<input type="checkbox"/> <u>Permit #</u>	<u>Status</u>	<u>Record Type Alias</u>	<u>Street #</u>	<u>Street Name</u>	<u>Type</u>	<u>Unit Type</u>	<u>Unit #</u>	<u>City</u>
<input type="checkbox"/> <u>B21002377</u>	Review In Process	Residential Open or Screened Porch Permit	1040	FAIRLANE	RD			WOODB

PERMIT SITE PLAN
LOT 22
 1040 FAIRLANE ROAD
FAIRLANE FARMS

From: Bernard, Dana
Sent: Tuesday, June 29, 2021 1:29 PM
To: NEVINSCONST@GMAIL.COM
Subject: Building Permit B21002377

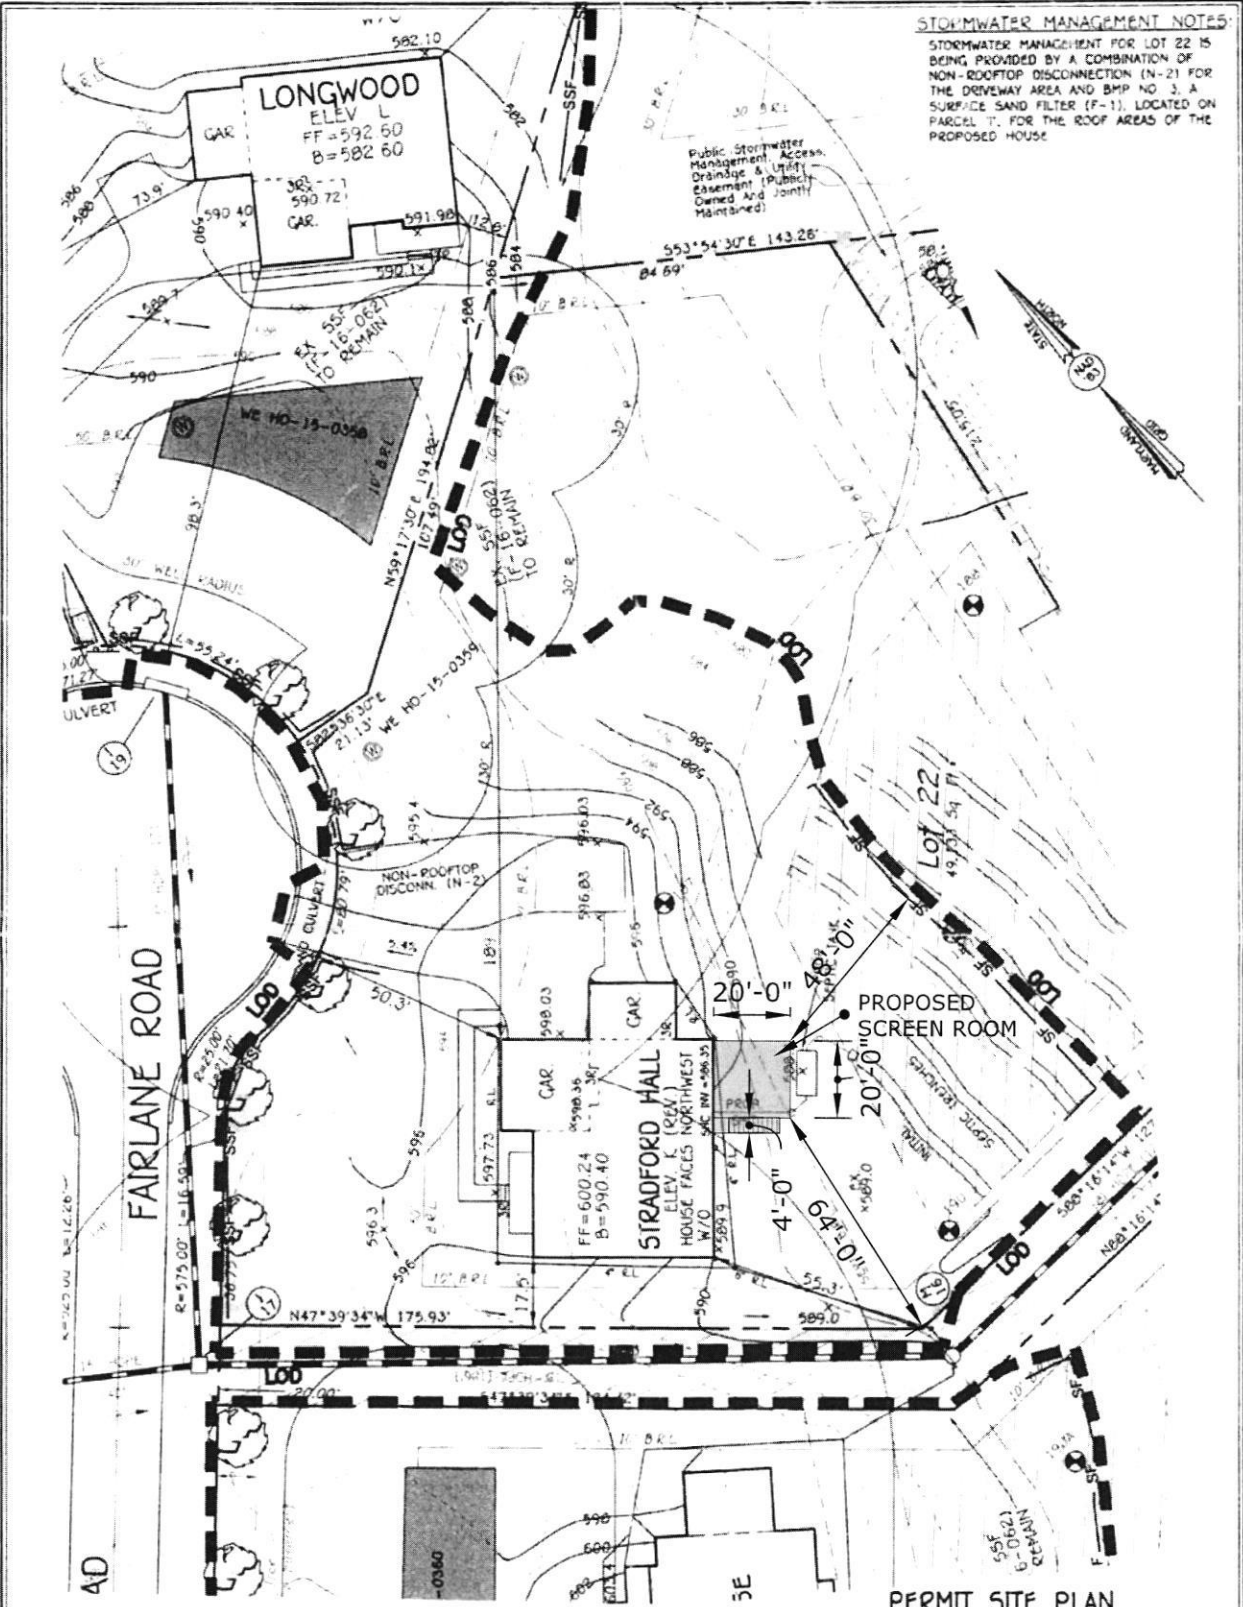
Must be 20 feet away from the tank.

I have reviewed your permit for your proposed addition is close to the septic tank and septic area. This distance is not within our required setbacks. Your septic system must be 20 feet away from your proposed addition. Please revise your plan and resubmit. If you need any additional assistance please don't hesitate to send me an e-mail regarding setback requirements.
